# National Committee on Uniform Traffic Control Devices

## NCUTCD Proposal for Changes to the Manual on Uniform Traffic Control Devices

<b>TECHNICAL COMMITTEE:</b>	Railroad/Light Rail Transit Committee
<b>ITEM NUMBER:</b>	19A-RR-01
<b>TOPIC:</b>	Mounting Height of Crossbuck and Tracks Signs on Flashing-Light Signals
<b>ORIGIN OF REQUEST:</b>	RR/LRT Technical Committee
<b>AFFECTED SECTIONS OF MUTCD:</b>	8C.02

**Figure 8C-1. Composite Drawing of Active Traffic Control Devices for Grade Crossings Showing Clearances**

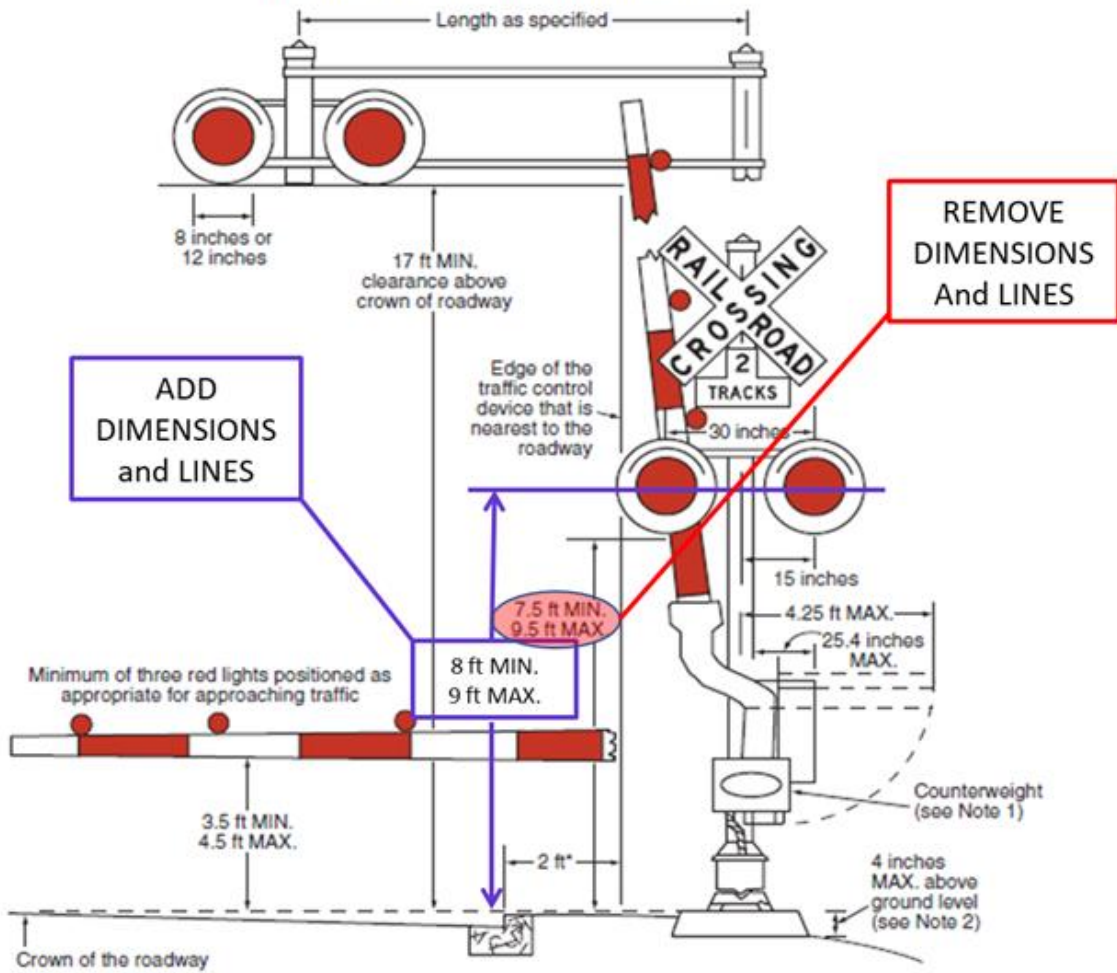
Existing guidance statements in section 8C.02 and in Figure 8C-1 provide many dimensions for the components of flashing-light signals. No dimensions are provided for the mounting of the Crossbuck and Track signs. Where multiple sets of flashing-light signals are used, the mounting location of the Crossbuck and Track signs may become too high to be visible to drivers or be illuminated by vehicle headlights. The proposed changes provide guidance to improve the visibility of the signs. The proposal makes changes to section 8C.02 that were previously approved by the NCUTCD Council as item 14B-RR-04 in June 2014.

56 <sup>02a</sup> The bottom of the Number of Tracks (R15-2P) plaque (when provided) should be located as  
57 low as practical above the flashing-light backgrounds. The Crossbuck (R15-1) sign should be  
58 located just above the Number of Tracks (R15-2P) plaque or if no plaque is present, the bottom  
59 of the Crossbuck sign should be located as low as practical above the flashing-light  
60 backgrounds.
